TRANSMITTAL COVER SHEET

DATE: 25 June 2024
TO: ALL PLAN HOLDERS OF RECORD
FROM: HUNTER SWATEK, AIA, PROJECT MANAGER
PROJECT: RAINBOW CITY RECREATION CENTER
GMC PROJECT NO. ABHM230021
RE: ADDENDUM NO. 4 AND
ACKNOWLEDGEMENT OF RECEIPT OF ADDENDUM NO. 4

ADDENDUM NUMBER 04

**PROJECT: RAINBOW CITY RECREATION CENTER
GM&C PROJECT NO. ABHM230021**

Scale: 1/4" = 1'-0"

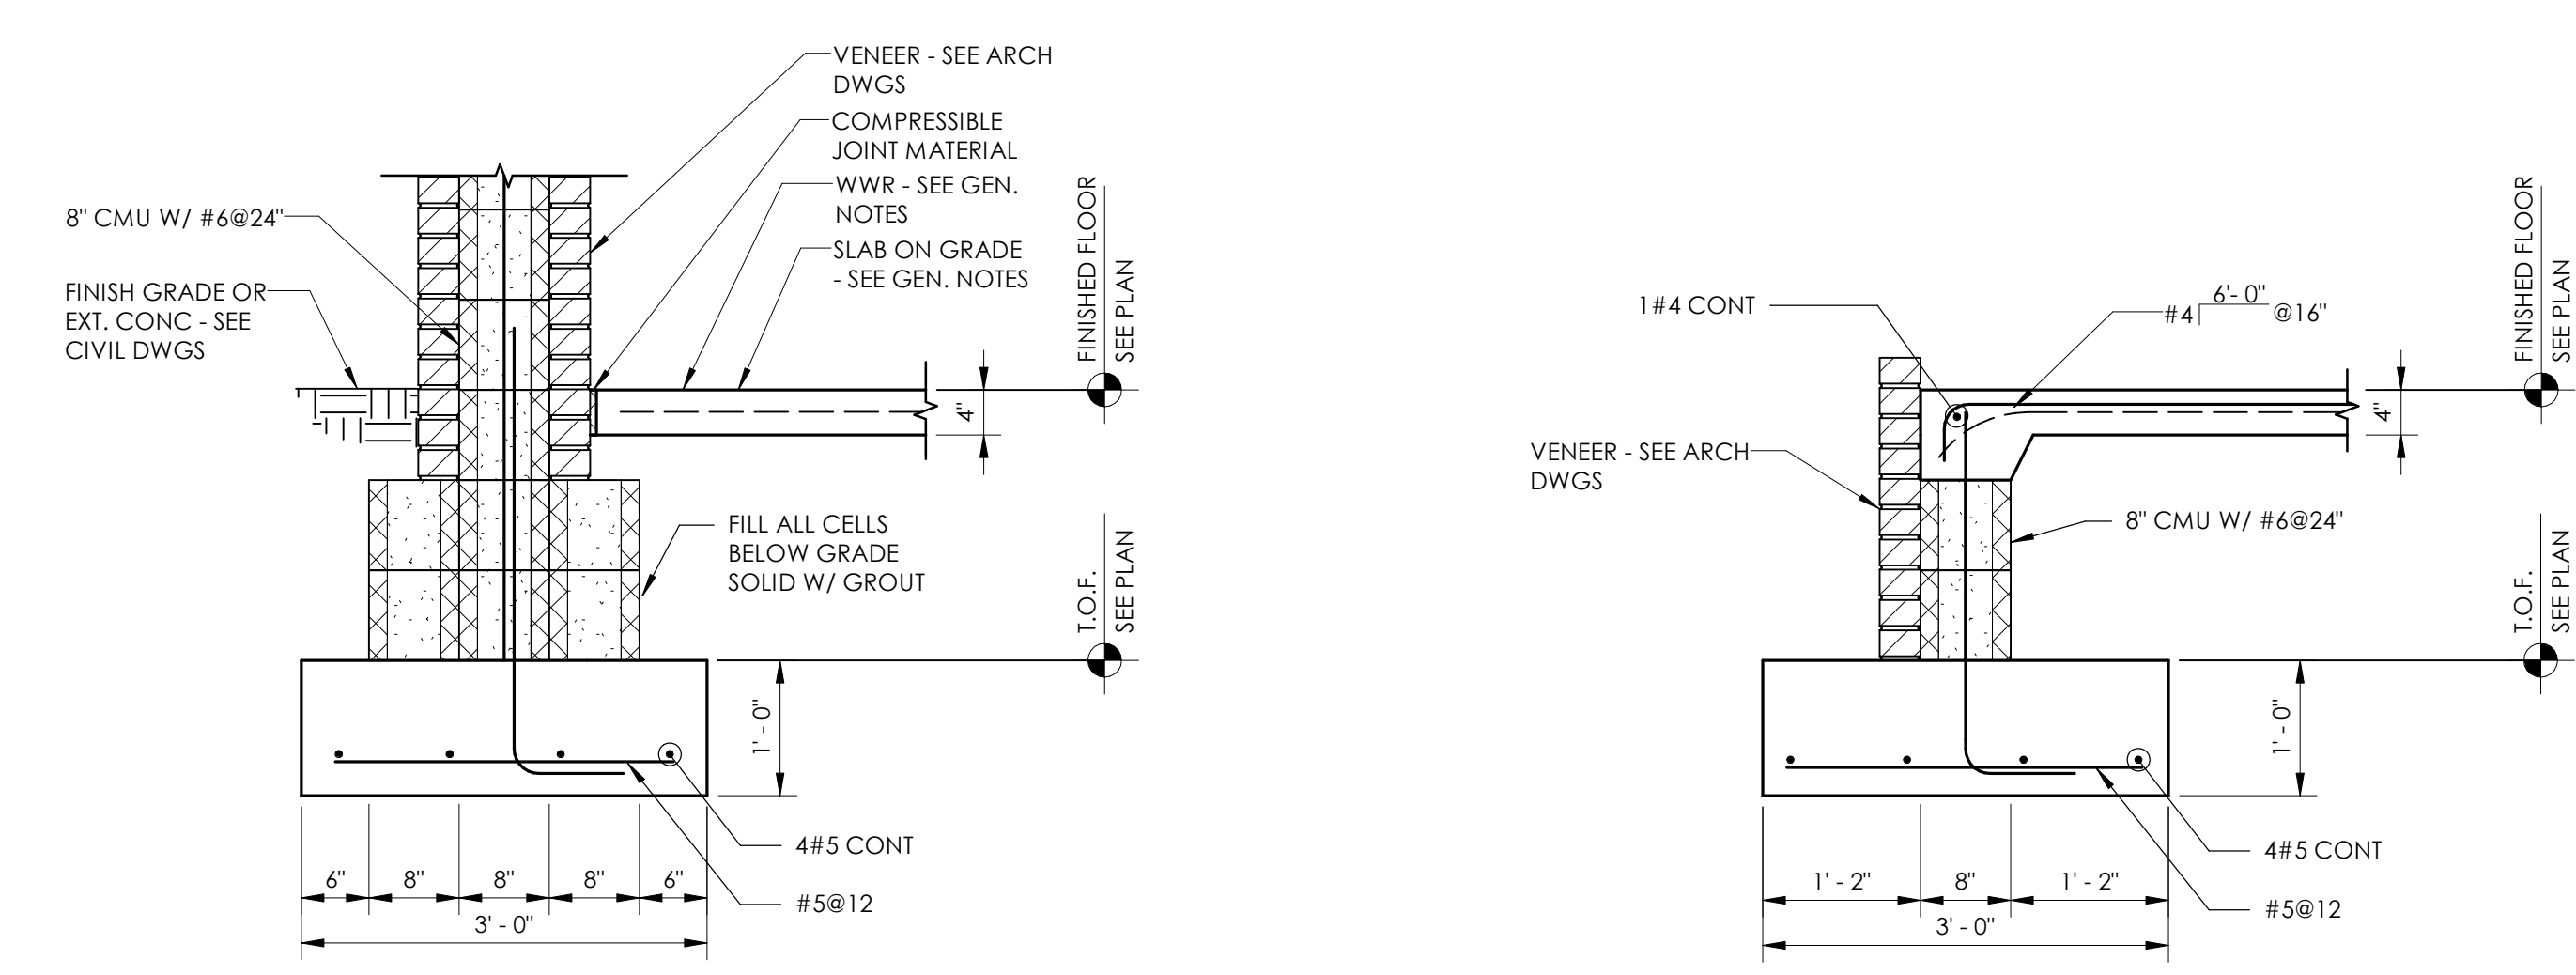
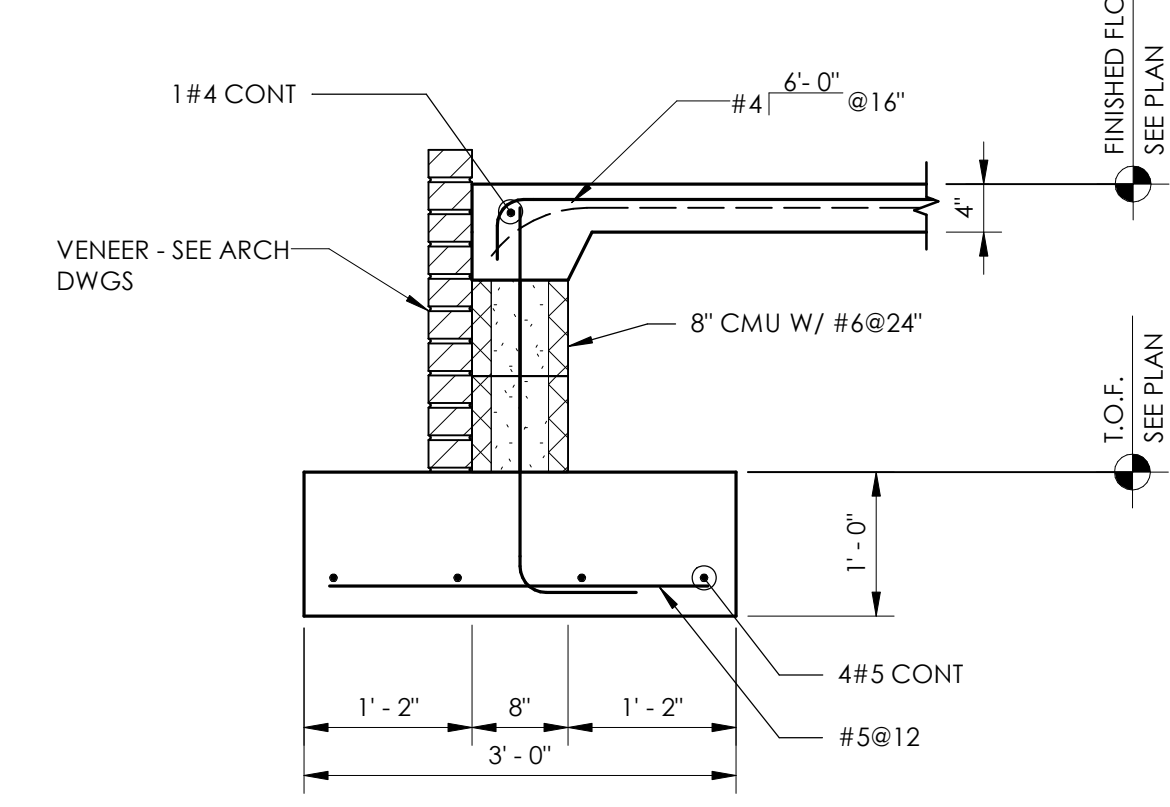
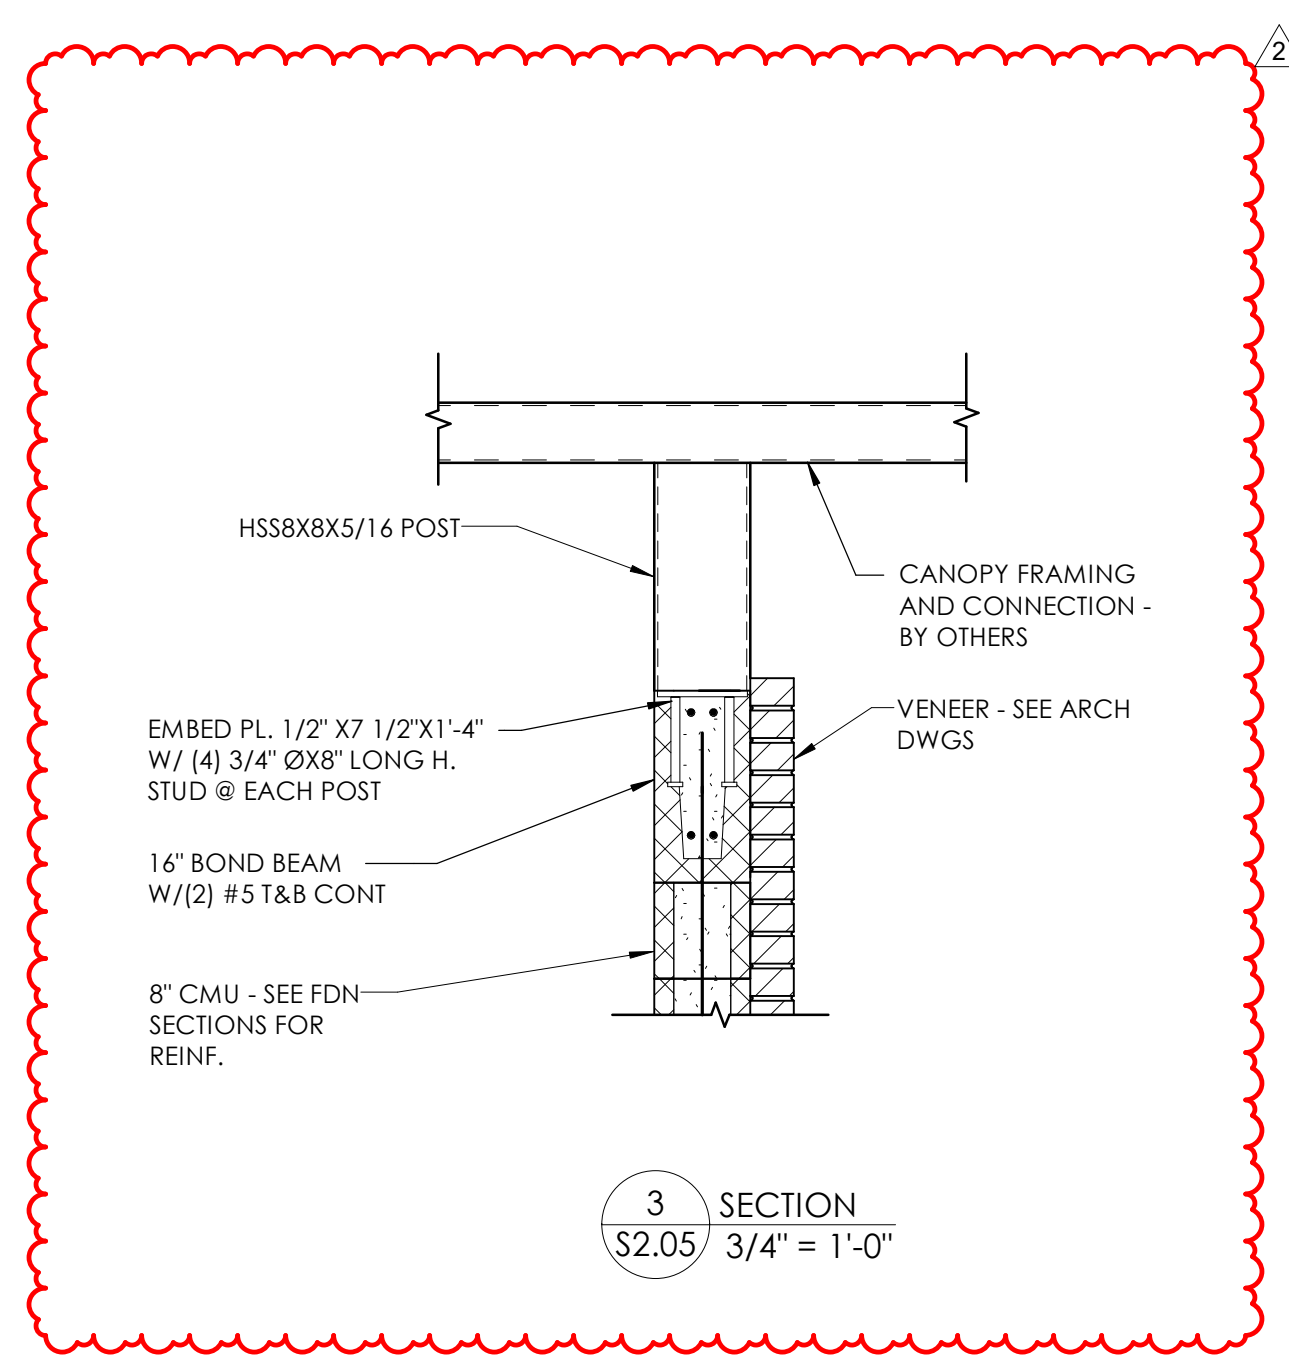
- a. ADDED New Sections
- R. **S2.05** – Amphitheatre Plans
 - a. REVISED Amphitheatre Canopy
- S. **S3.05** – Sections
 - a. CREATED New Section
- T. **E0.02** – Electrical Site Power
 - a. REVISED Transformer Pad Location
- U. **E5.02** – Panelboard Schedules and Diagrams
 - a. REMOVED RPA1 to RPB2 Connection
- V. **E7.01** – General Electrical Legend & Notes
 - a. ADDED FB1 Note
- W. **SP1.01, SP1.02, SP2.01, SP2.02, SP2.03, SP2.04** – Pool Addendum 04
 - a. REVISED Drawings
